Docket Item #5  
SUB #2007-0001  
POTOMAC AVENUE SUBDIVISION

Planning Commission Meeting  
May 1, 2007

**ISSUE:** Consideration of a request for approval of a subdivision plat for dedication of the Potomac Avenue public right-of-way.

Figure 5A. Looking North - Potomac Avenue in the Retail Center

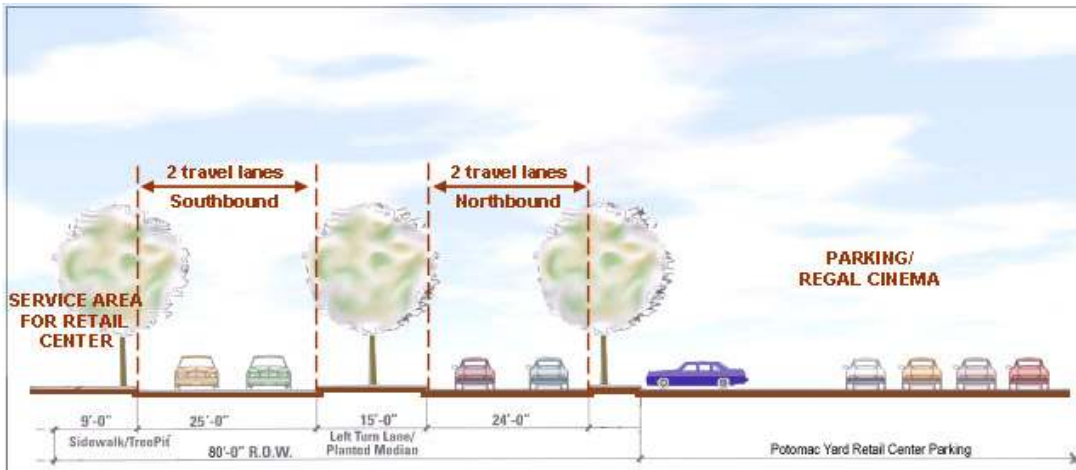
The proposed subdivision is the final approval necessary to allow Potomac Avenue to be constructed. As previously discussed, this is an important roadway for Potomac Yard and the City. The applicants are proposing an 80-foot right-of-way for the retail center portion of Potomac Avenue (Figure 5A), while a 90-foot right-of-way for Potomac Avenue was approved as part of the infrastructure plan in compliance with the 1999 CDD Concept Plan and Design

Guidelines (Figure 5B). An 80-foot right-of-way is proposed because the area is adequate to provide the number of travel lanes in each direction and the median envisioned by the CDD Design Guidelines. The 10-foot difference is essentially the absence of on-street parking and variation in sidewalk widths. Staff supports this approach because the ultimate sidewalk width,

on-street parking, any additional right-of-way, etc., will be evaluated when the retail center redevelops. Staff recommends approval of the proposed subdivision to enable the construction of this important roadway with the understanding that additional sidewalks and or right-of-way will be obtained as part of the redevelopment of the retail center.
